# Staff Report

To: Salt Lake City Planning Commission  
From: Casey Stewart; 801-535-6260  
Date: April 17, 2014  
Re: PLNPCM2014-00045 Conditional Building and Site design for 151 Tower Office Building

## CONDITIONAL BUILDING AND SITE DESIGN REVIEW

**SITE PLAN**

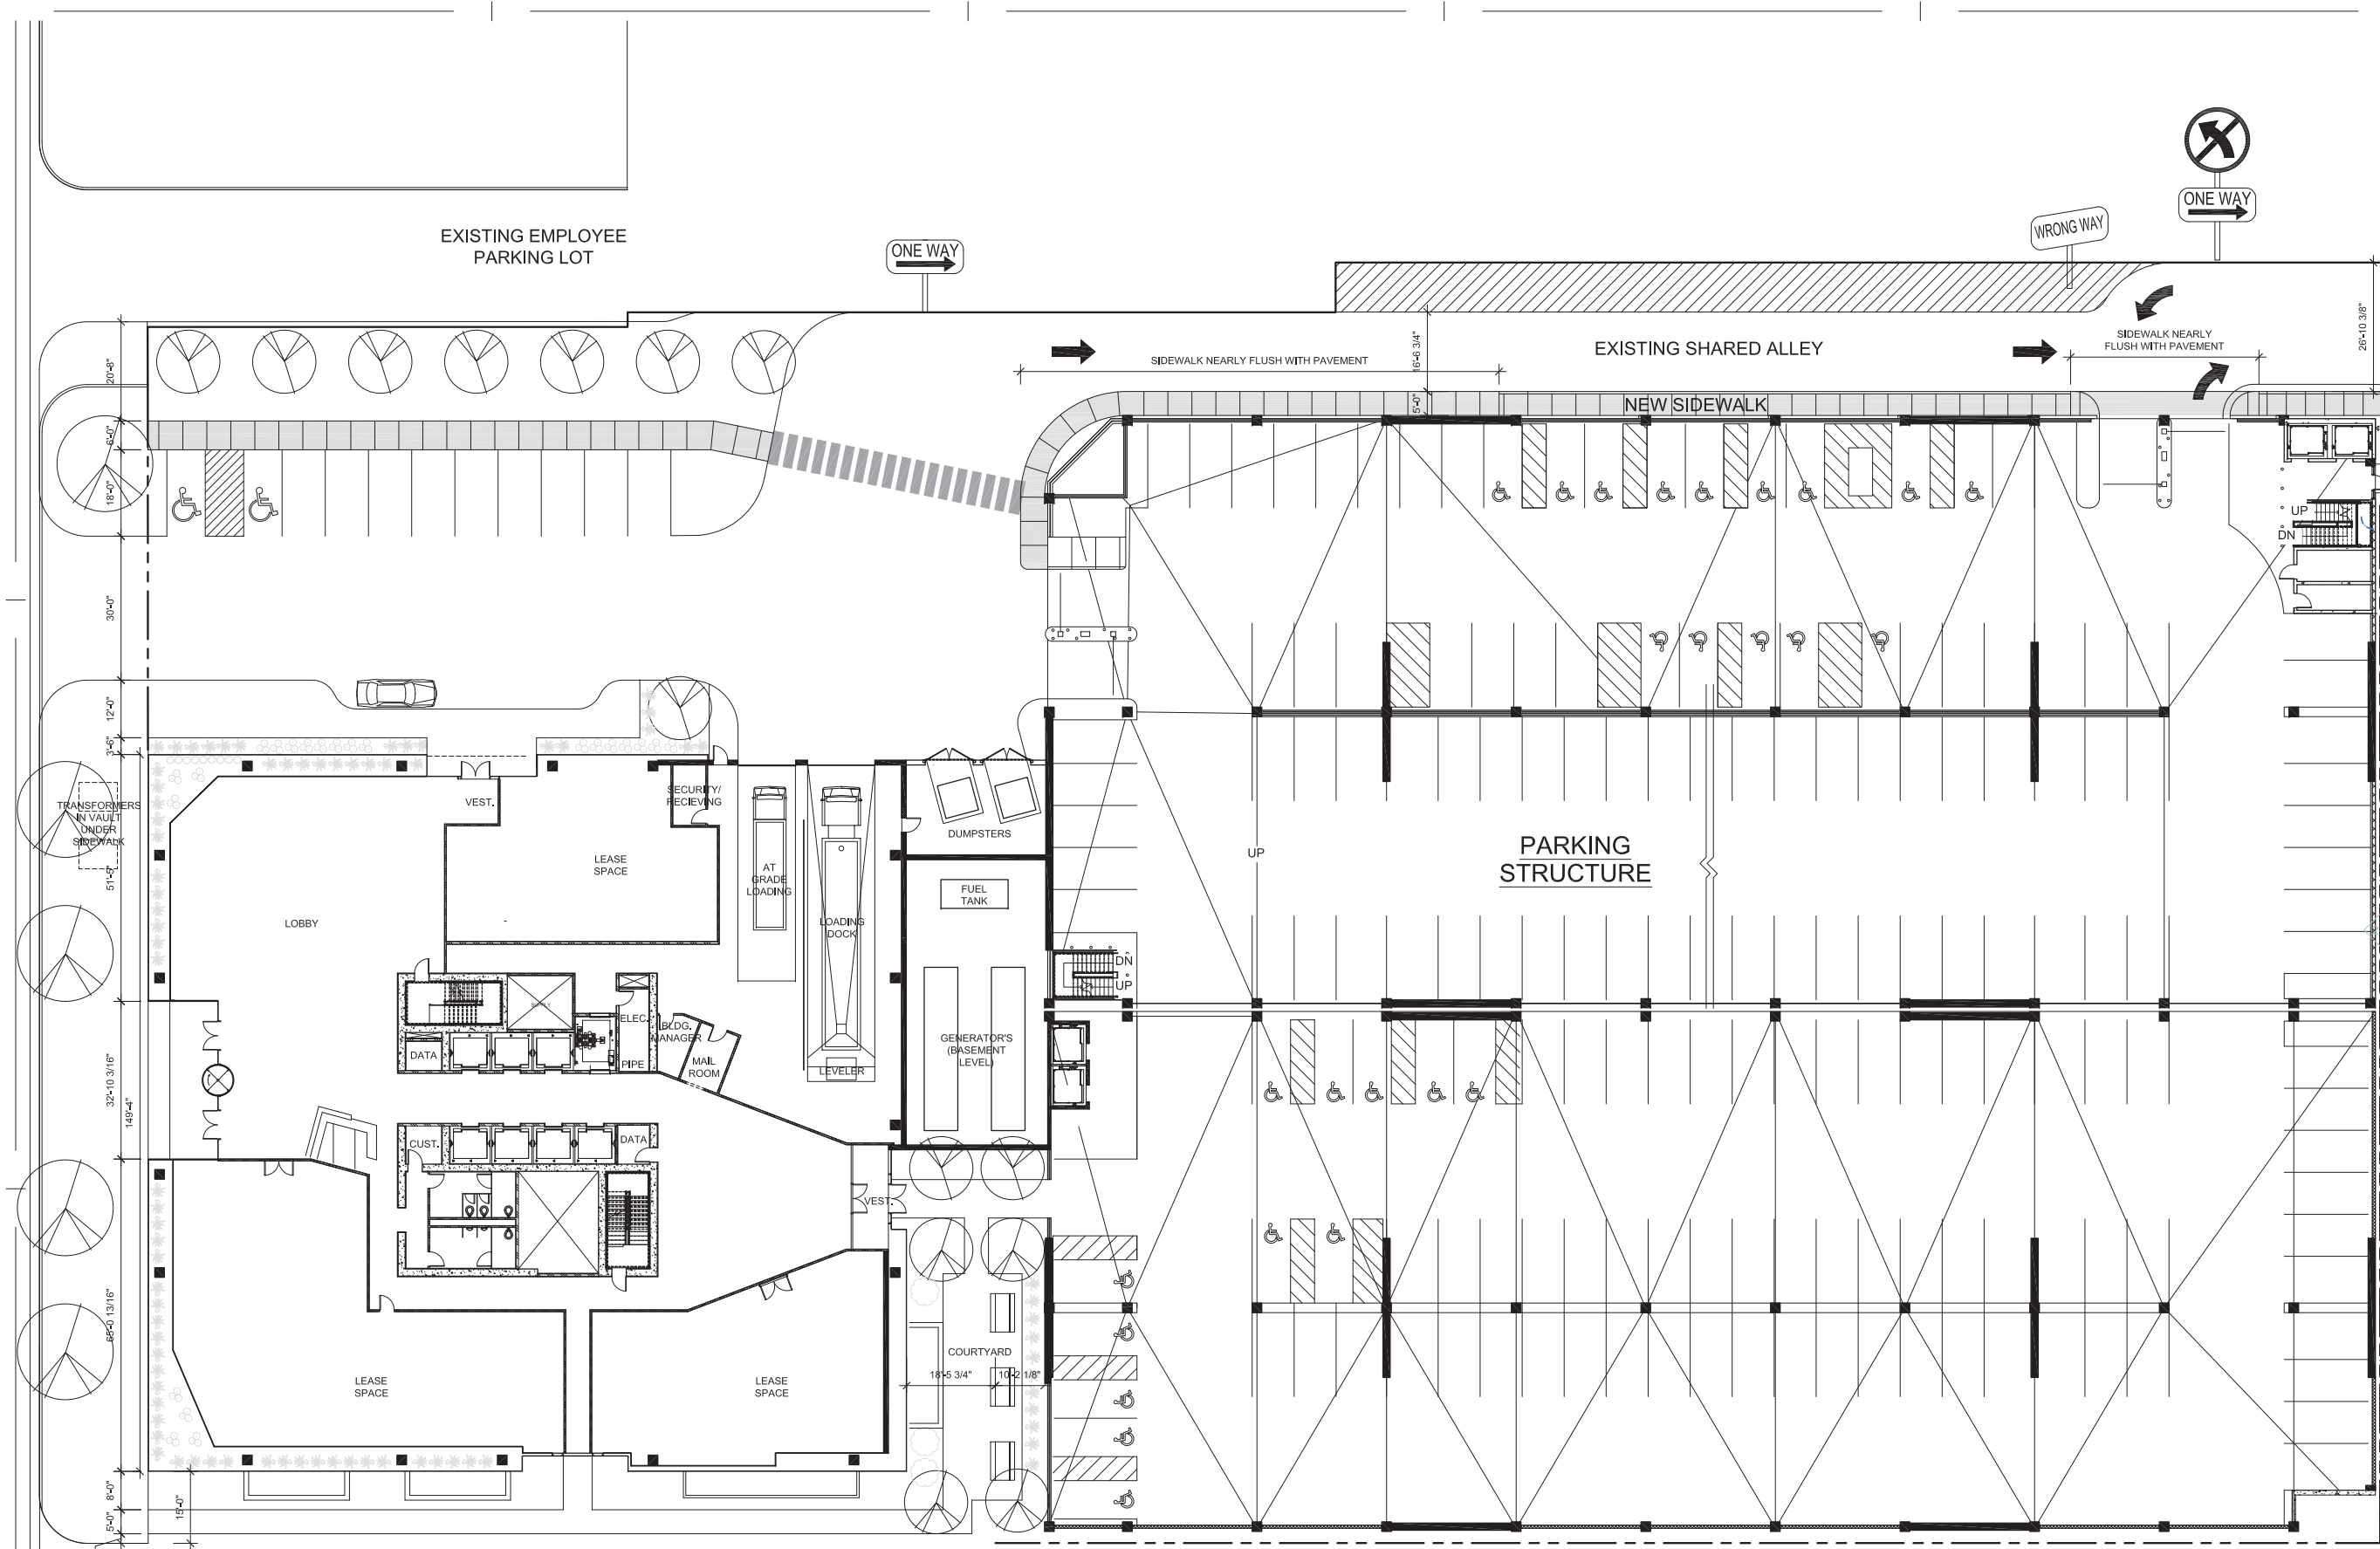
This proposal is to be consistent with the Standards For Design Review and Standards For Design Review For Height as noted in 21A.59. This proposal has not been reviewed for compliance to percentage or type of first floor glass, compliance to minimum and maximum parking requirements, screening of service areas, midblock walk ways or landscaping requirements; except to note that the Boyer 151 Tower Project Description indicates that 6 street trees will be provided and only 5 are shown.

**REVISED PARAPET DESIGN**

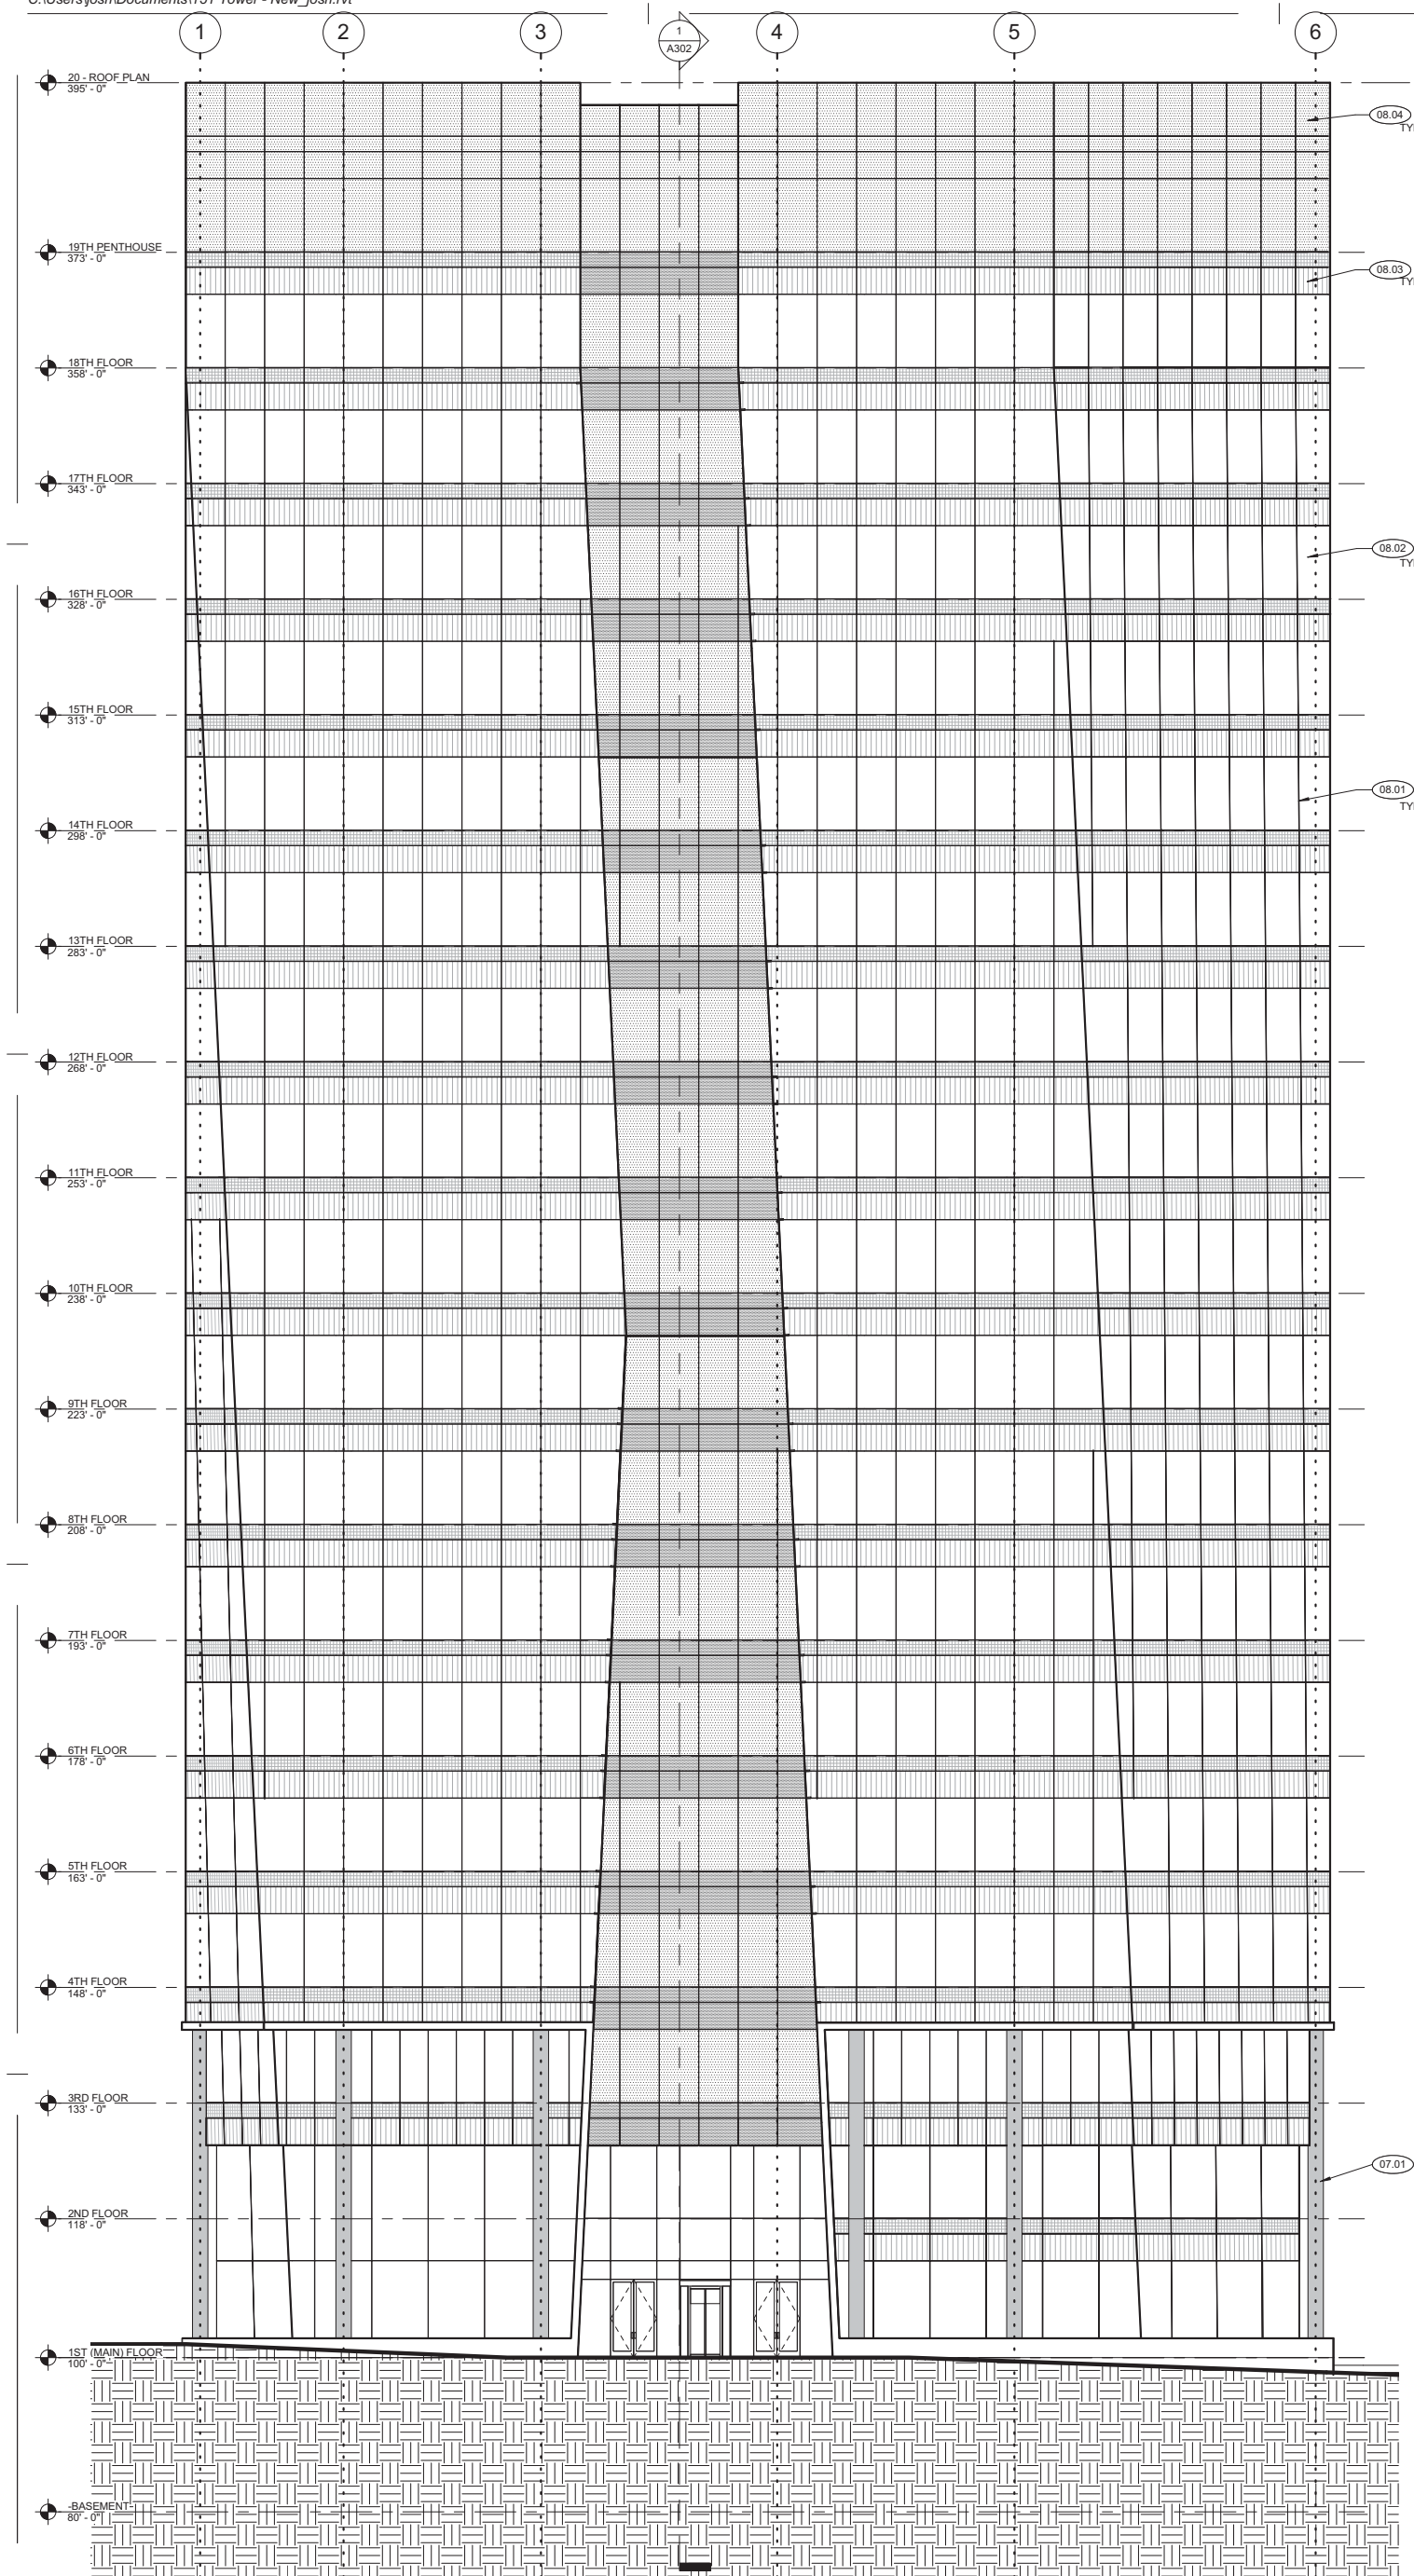
**Issue 1: Roofline architecture - unresolved**

The original roofline architecture was very similar to other recent office tower projects at 222 South Main Street (completed) and 111 South Main Street (under construction). These buildings have flat rooflines consisting of glass parapets. A district roofline is a criterion when seeking extra building height. Based on initial planning staff concerns of an indistinct roofline (when compared to those recent projects), the applicant modified the roofline in an attempt to meet the criterion; however this latest roofline version does not sufficiently distinguish itself from the other projects, or the original roofline design – especially for the amount of extra height requested.

The building design overall uses varying angles and cuts to create subtle visual illusions of building form; and the proposed roofline continues this theme, but its similarities with other recent buildings remains readily apparent. Both designs proposed by the applicant are included with this report for the planning commission's consideration. Lacking more distinct roofline architecture, planning staff cannot fully recommend in favor of the extra building height requested, as discussed in the analysis that follows.

The modified design involves three revisions from the original design submitted to the City:

1. Modulate the top of the parapet more by greatly increasing the vertical depression at the niches. We originally had two feet drops in the top of the glass parapet at the niches and now we are proposing six feet. With three times more variation in the top of the building cornice line than we had in original design, it strongly accentuates the four quadrants of the building façade as independent masses separated by the niches. This castellation of the façade is very distinct from the 111 Building which has no relief in either the face or top of its parapet wall. It also is more uniform and complete in its appearance from that of the 222 Building which, while it has a dressed up front façade, reverts to exposed penthouse boxes on the backside of the building.

2. We have modified the glass parapet from the frosted glass in our original design, to nearly clear glass which is also different than any other building in the downtown, including 111, and 222.

3. We have suggested a subtle pattern be included on the face of the penthouse so that it becomes an integral part of the design, not just a mechanical box we are trying to hide. The actual pattern (shown as vertical grey shapes in the rendering) may take more time to fully develop, but we have shown a concept that integrates the vertical lines of the top of the building in an artistic vertical expression.
